UNITED STATES PATENT AND TRADEMARK OFFICE

APPLICATION NO.	FILING DATE	FIRST NAMED INVENTOR	ATTORNEY DOCKET NO.	CONFIRMATION NO.
10/616,367	07/08/2003	Michael Black	MIB-102	2320

Office Action Summary	Application No. 10/616,367	Applicant(s) BLACK, MICHAEL	
	Examiner Henry M. Johnson, III	Art Unit 3739

Fig. 10A

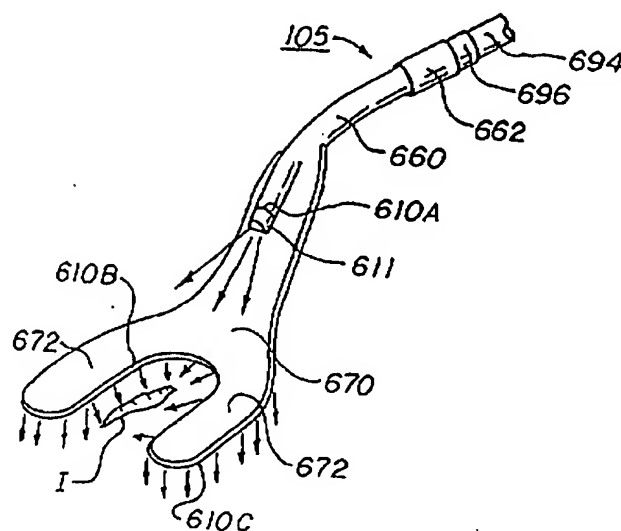
the user with a variety of other information, such as, sensing and alerting a user when a treatment session is complete, when the oral appliance is properly positioned, when the oral appliance is in contact with tissue, and/or if the temperature in the treatment area rises above a predetermined level. Sensors can also be used with a controller to provide auto-feedback control of a treatment session(s) (paragraph 0098). The controller inherently provides the ability to control the fluence of the light sources. The alert inherently must be audio, visual or tactile. The controller associated with the feedback or the switch in the handle provides selection capability. The switch is broadly interpreted as a means for displaying data related to the light; i.e. on or off. The handle portion and the body portion are removably and irreplaceably (disposable) mated with one another to allow cleaning and/or replacement (paragraph 0065). Altshuler et al. do not teach multiple arms to support the sources. Williams et al. disclose a handheld light device with the lights (Fig. 10A, # 610) mounted on multiple arms (Fig. 10A, #

672). It would have been obvious to one having ordinary skill in the art at the time the invention was made to use the multiple arms as taught by Williams et al. in the device of Altshuler et al. to extend the area of coverage of the light beams.
